TAXIWAY F RECONSTRUCTION

BATON ROUGE METROPOLITAN AIRPORT

ADDENDUM NO. 1

DATE ISSUED: JULY 28, 2026

CONTRACTOR ACCESS PLAN

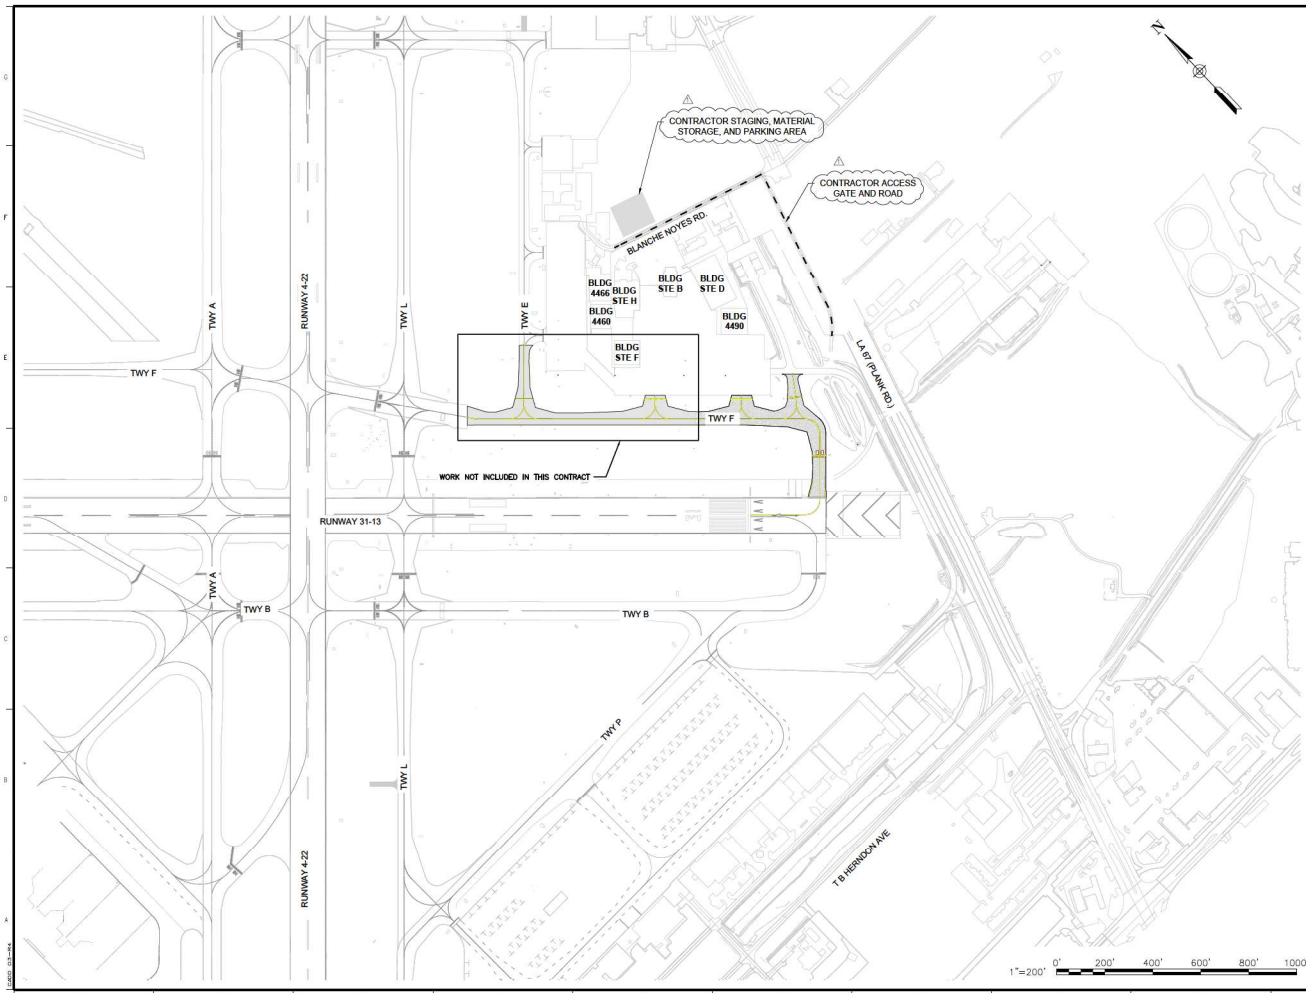
- L-125-5.11 LED Retrofit Kit, S13(3 Module)
- Sheet GI002, CONTRACTOR ACCESS PLAN

- Access has been revised.
- Sheet GI101, CONSTRUCTION SAFETY PLAN AND AIRPORT SAFETY PLAN PHASE 1
 - Temp stockpile area added.
 - New notes regarding FOD control added.
- Sheet GI102, CONSTRUCTION SAFETY PLAN AND AIRPORT SAFETY PLAN PHASE 2
 - Temp stockpile area added.
- Sheet GI201, SCP AND ASP DETAILS
 - Removed Portable Lighted “X” Runway Closure Marker
- Sheet CS202
 - Removed Transition Between Rigid and Flexible Pavement Sections (added to JL201)
- Sheet JL201, ENLARGED JOINT LAYOUT PLAN
 - Alt 2 added to joint layout plan.
 - Revised Detail A3 and added legend.
 - Joint layout design completely revised.
- Sheet E-604, SIGNAGE SCHEDULE
 - Added note 3
